AMENDMENTS TO THE DRAWINGS

REMARKS

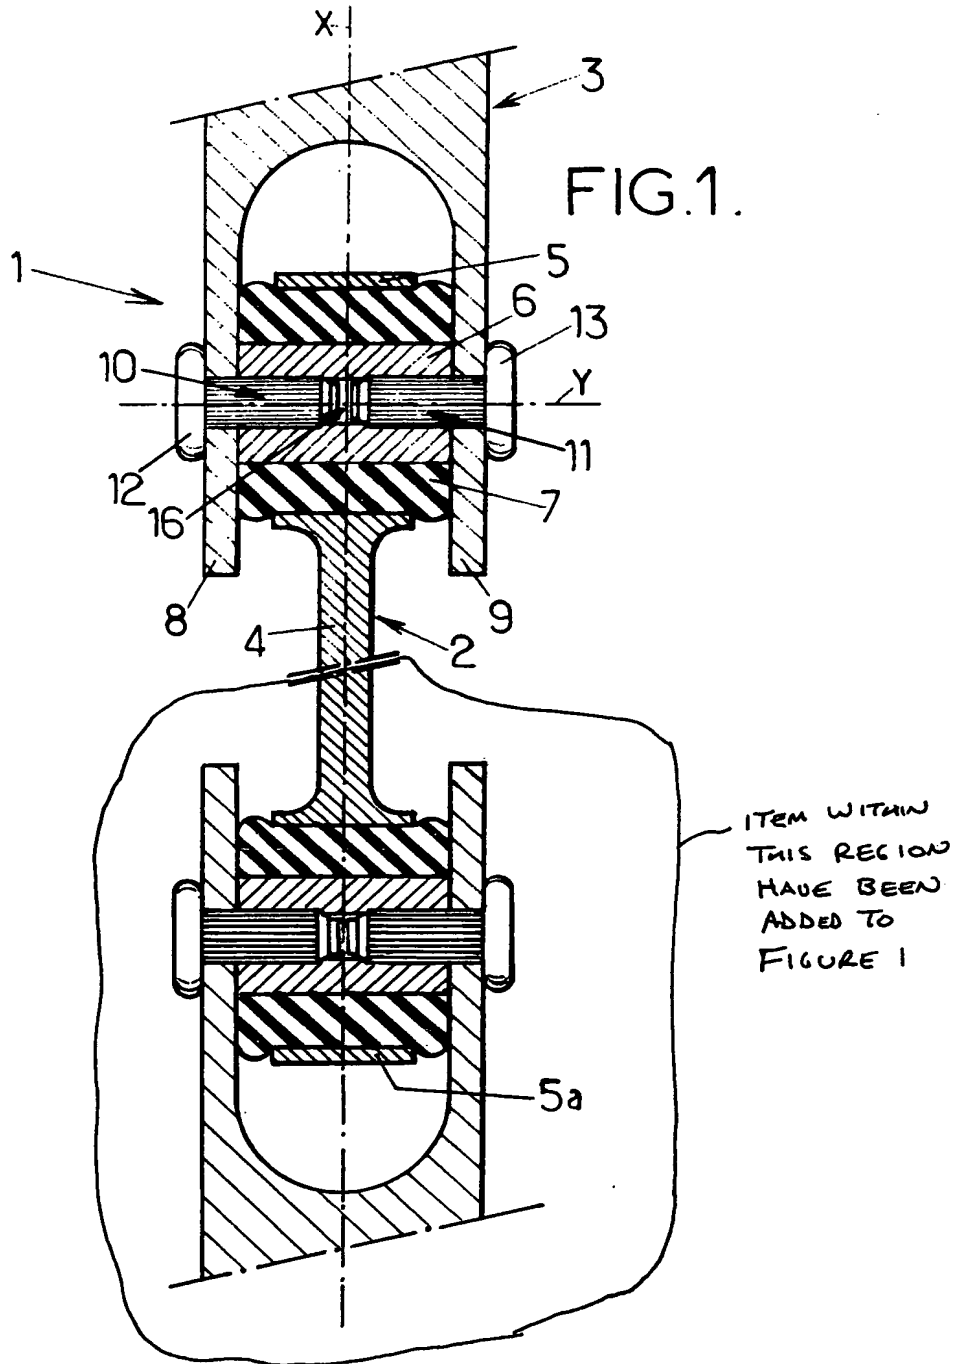
The attached replacement sheet of drawings includes changes to Figure 1. This sheet, which includes Figures 1-2, replaces the original sheet including Figures 1-2. Figure 1 was changed to depict the “second sleeve” element, identified by reference number ‘5a,’ and the structure of the vibration damping device pertinent for showing the location of the second sleeve 5a.

The Examiner objected to the drawings because the “second sleeve” recited in claim 4 is not shown in the originally filed drawings. Applicant submits herewith a replacement drawing sheet showing Figures 1-2, and an annotated drawing sheet showing Figures 1-2 and the changes made to Figure 1. In particular, Figure 1 was changed to depict the “second sleeve” element, identified by reference number ‘5a,’ and the structure of the vibration damping device pertinent for showing the location of the second sleeve 5a. Support for the change to Figure 1 is located in the specification at page 1, lines 8-19, and page 5, line 8 to page 6, line 4. Applicant respectfully requests that the Examiner withdraw the objection to the drawings.
